Access Compliance Report

Public Rights-of-Way

Intersection ID: 12977	Main Street: W_PALMER_ST	Cross Street: S_CHURCH_ST	Location: NW
ADA ID: CDCD2340D363	Ramp Type: PerpDiag	Initial Pass/Fail: Pass	Overall Compliance: No
Severity Score: 5			
Codes/Mitigation Info/Possible Solution		Field Measurements/Component Compliance

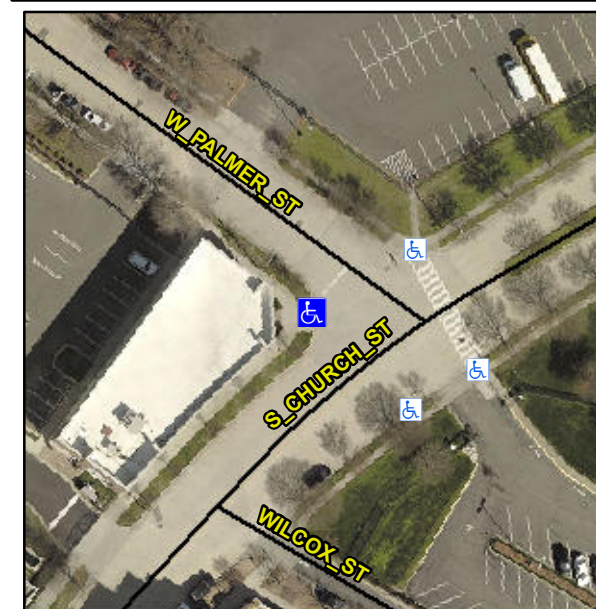
Remove & Replace Curb Slope and Extend Ramp. Remove & Replace Gutter.

Not Found, R304.5.4
